CLAREMONT BUSINESS PARK 2 FILING NO. 2

FINAL PLAT
CLAREMONT BUSINESS PARK 2 FILING NO. 2
JOB NO. 10-020
DATE PREPARED: 02/27/2023
DATE REVISED: 04/10/2023

PCD FIL. NO. VR233

SHEET 1 OF 3

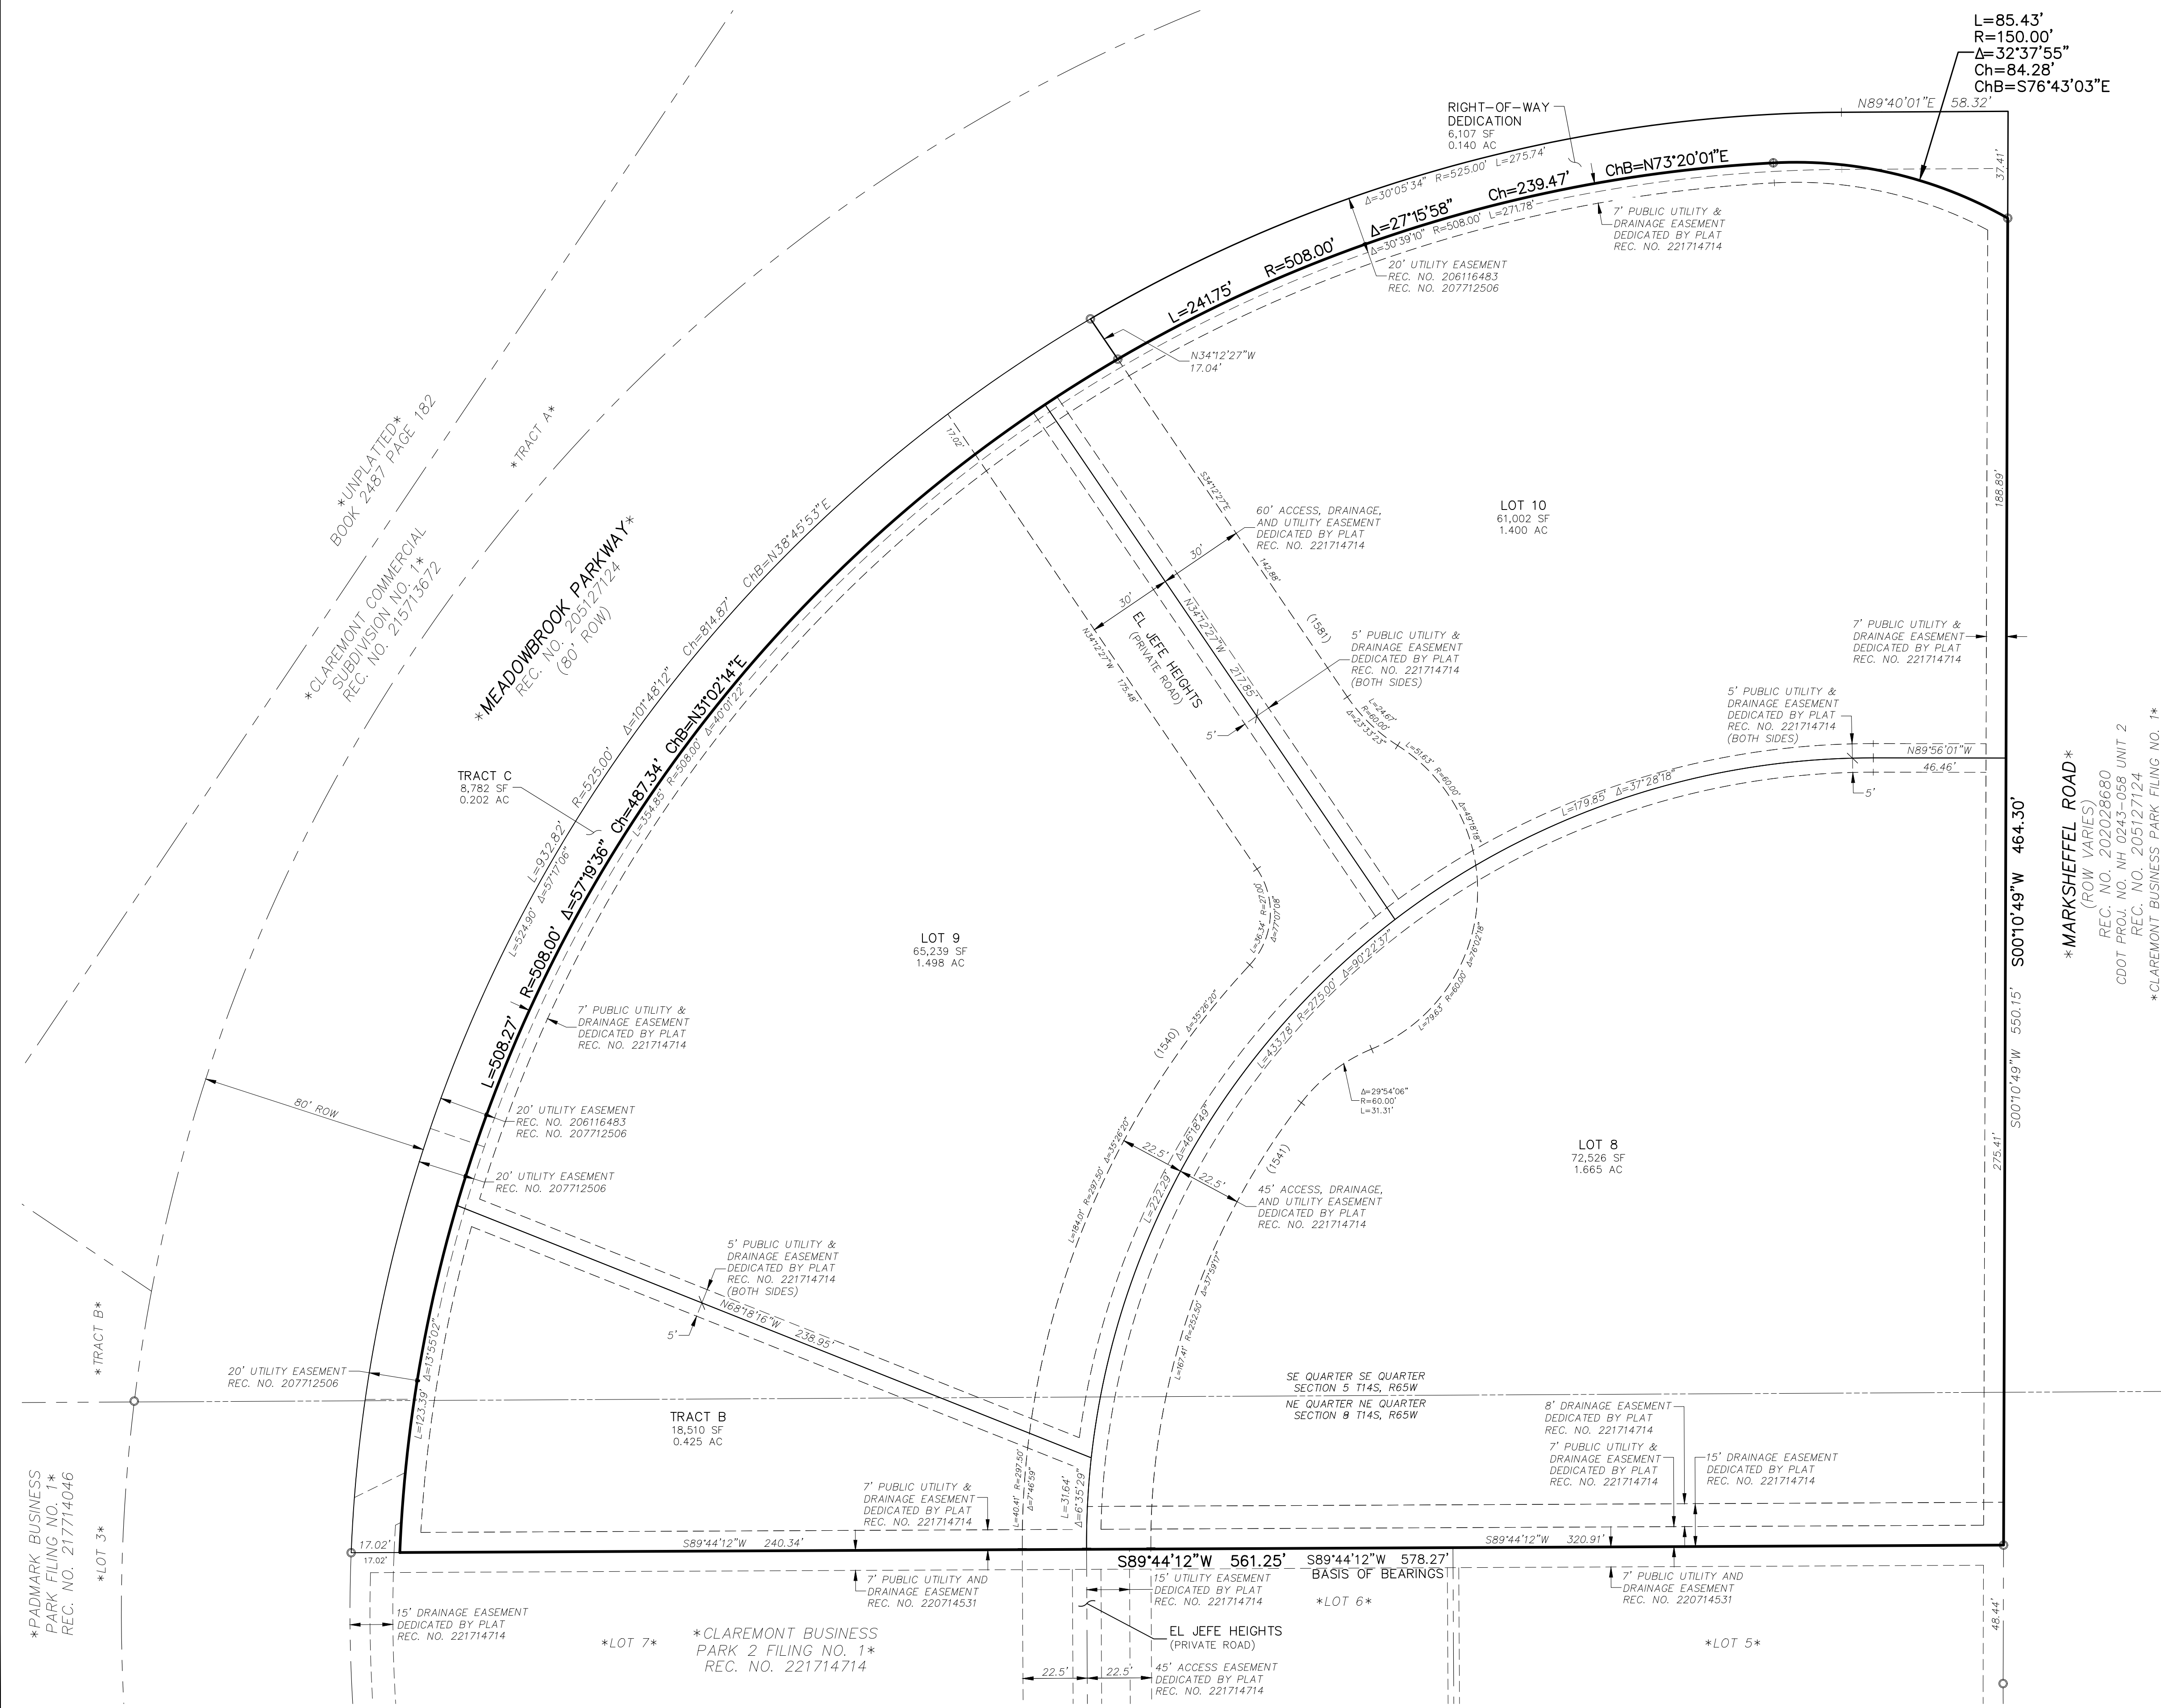
Note 12 is a duplicate of note 8, please remove.

SHEET 2 OF 3

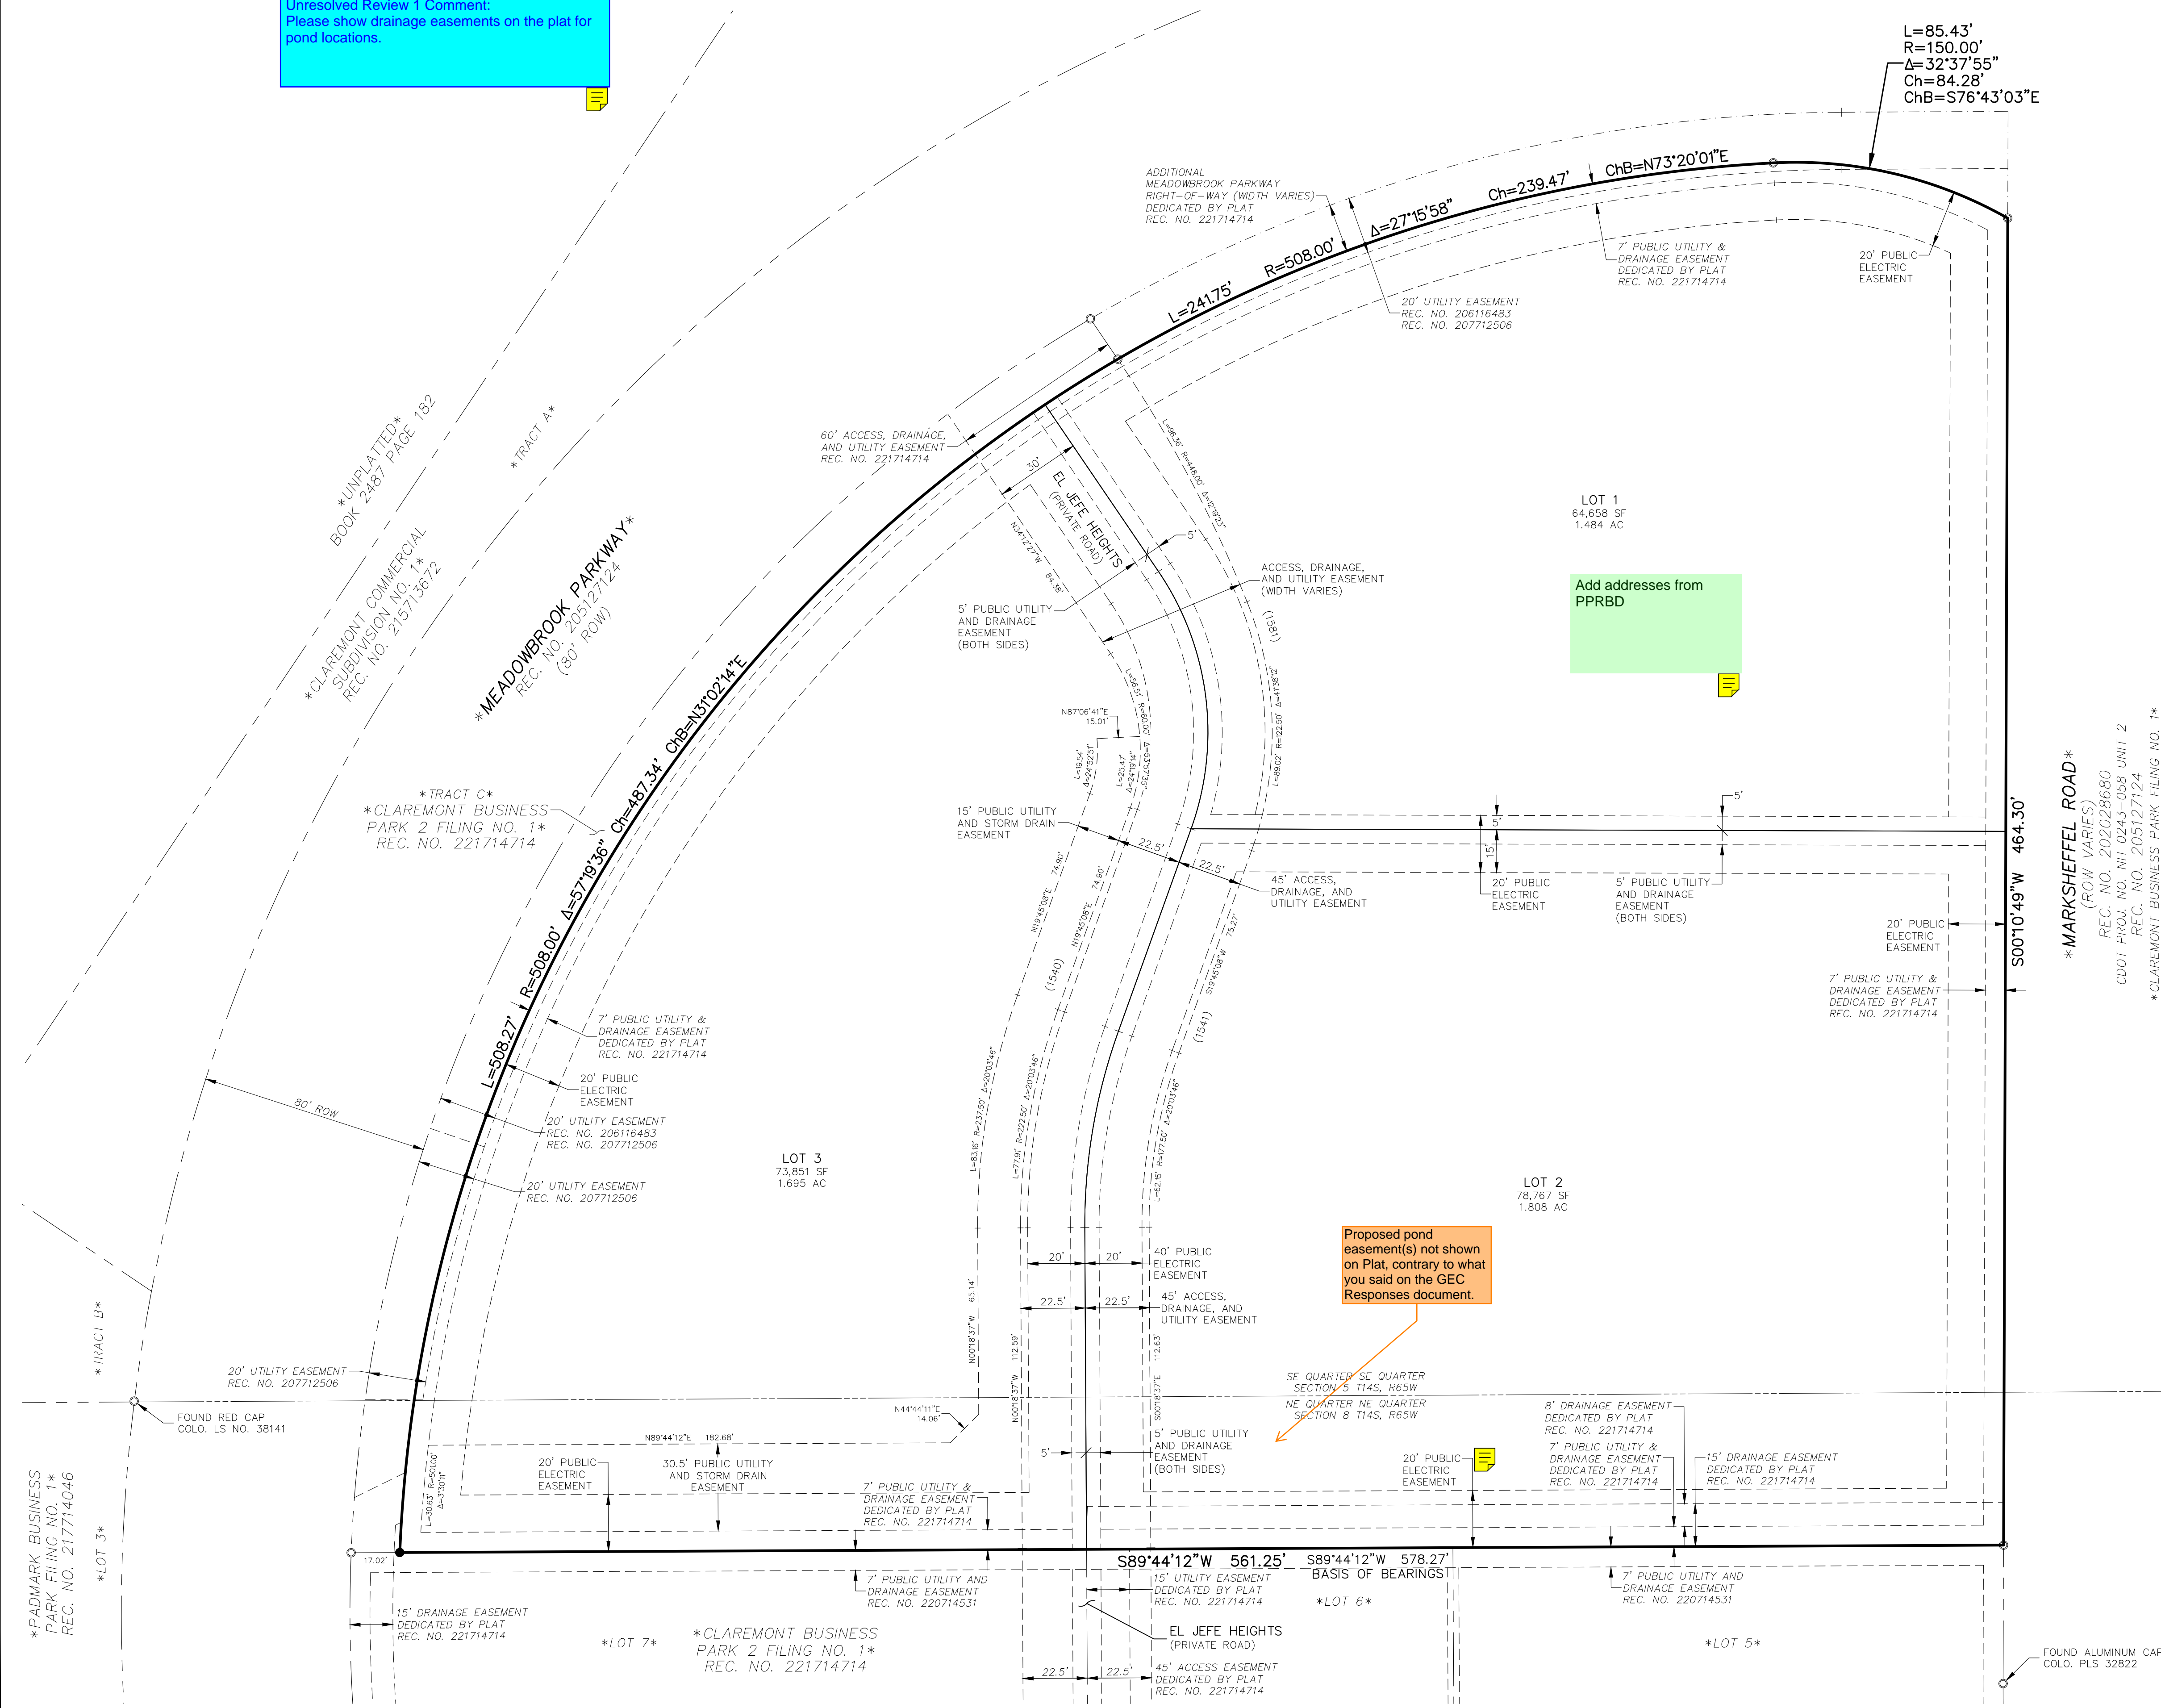
Unresolved Review 1 Comment:
Please show drainage easements on the plat for pond locations.

Proposed pond easement(s) not shown on Plat, contrary to what you said on the GEC Responses document.
